# Project #20-046 3rd Gen Machine Located at 2200 N 600 W

#### REPORT SUMMARY...

Design Review Permit

3RD GEN MACHINE DESIGN REVIEW 2200 NORTH 600 WEST LOGAN, UT 84321

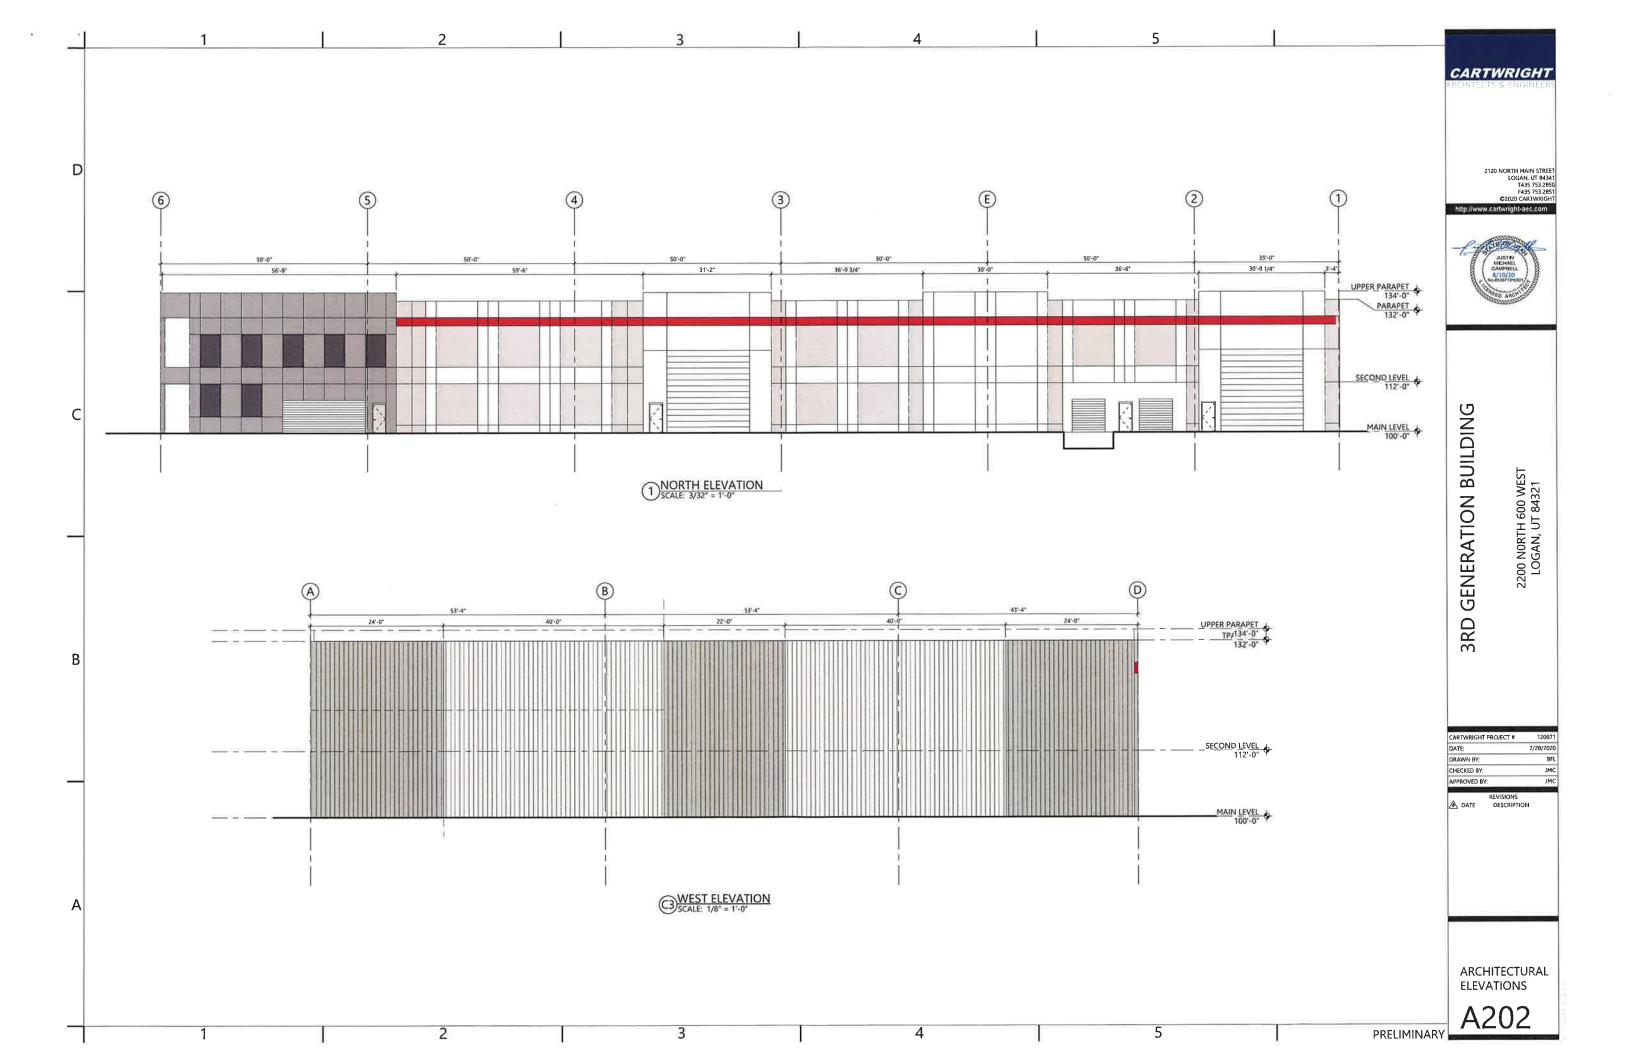
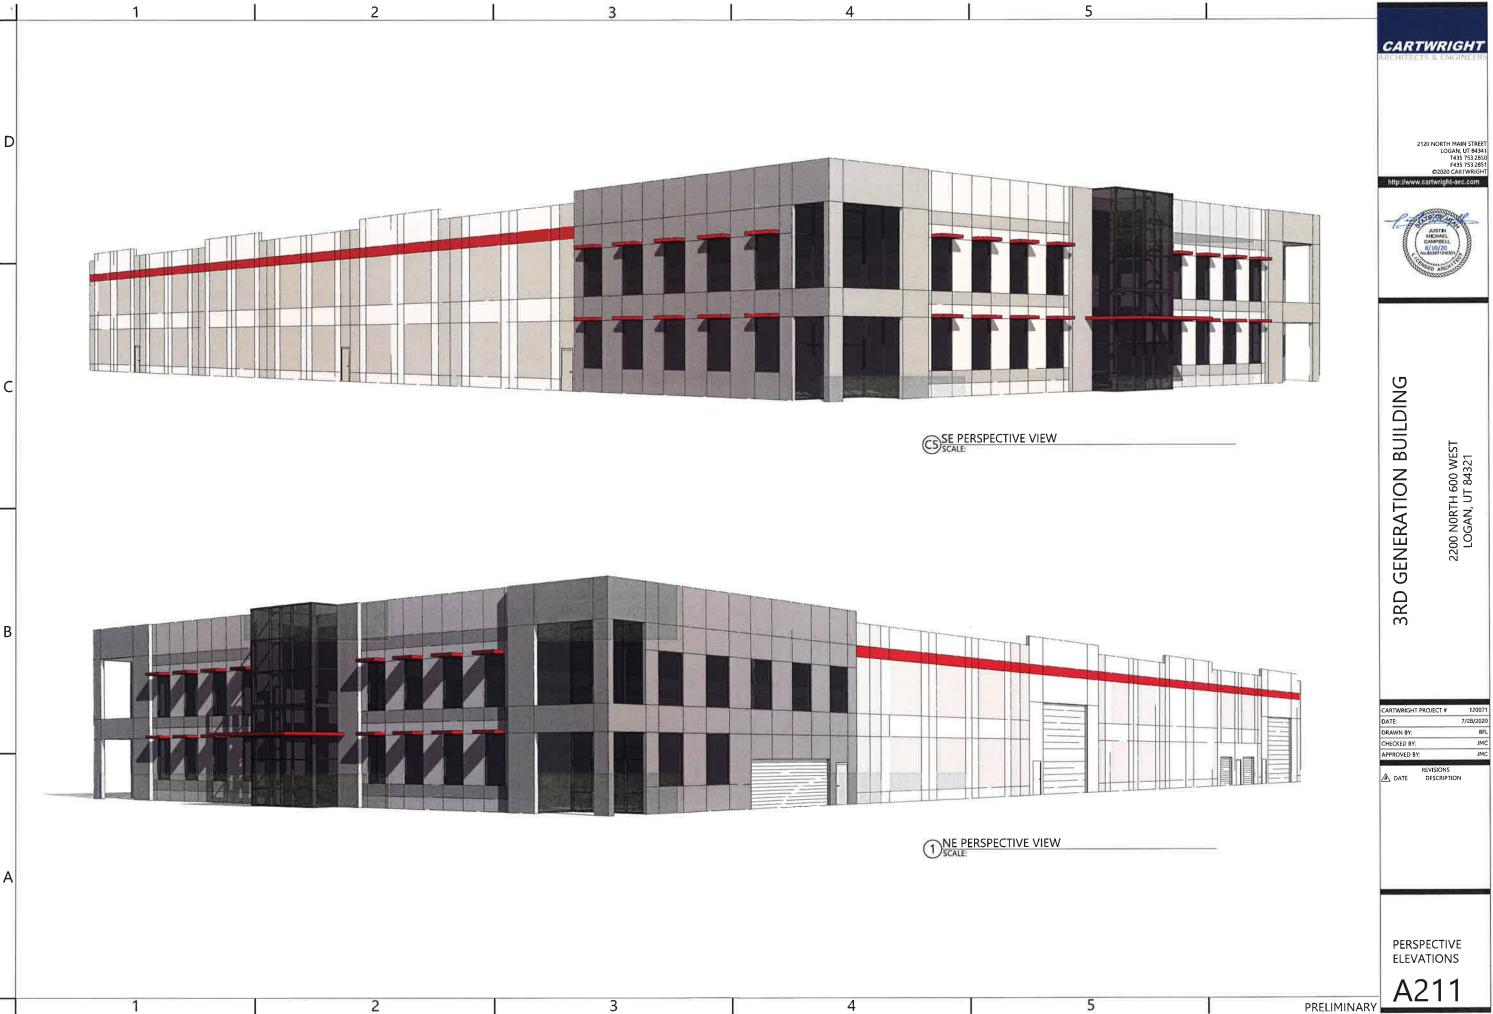
The proponent would like to consider the south elevation along 2200 North as the front of the building, however, as proposed, the main entrance is oriented to the east facing the parking lot. This orientation does not meet building design standards. The building materials proposed are textured concrete, perforated decorative metal panels and architectural metal panels. The south elevation (front of building) facing 2200 North is shown with approximately 12% actual transparency. The majority of fenestration along the front south elevation are 'false' windows made of perforated decorative metal panels as the temperature variance from south facing glass windows would impact the production of precision milling operations inside the building.

- 1. All standard conditions of approval will be recorded with the Design Review and are available in the Community Development Department.
- 2. The buildings front façade (south elevation) shall have a main entrance unless Planning Commission approves otherwise.

- 3. The front façade shall have 30% transparency instead of proposed 12% unless Planning Commission approves otherwise.
- 4. The front parking setback shall be adjusted 20'.

- 5. Walkways shall be added in areas that connect the surrounding streets to the building entrances, within the parking lot and outdoor amenity areas.

- Install all utilities and infrastructure in 2200 North along frontage (12" water main, 24" sewer, irrigation/storm water pipe 15" minimum). Note 8" sewer required for development upsize to 24" to be paid by North Logan.

- Existing depth of sewer manhole in 600 West is approximately 5.42'. It does not appear
      that a minimum cover over the proposed 6" sewer line can be maintained. Original
      subdivision called for a common lift station to collect and pump back to 600 West. This
      original plan needs to be maintained for this development. Lift station shall be privately
      owned and operated and will require a HOA or equivalent to be established.

- 2200 North shall be paved to a minimum width of 20' of asphalt to support 2-10' travel lanes
    - Provide a pavement section on 2200 North and 600 West for a Collector road.
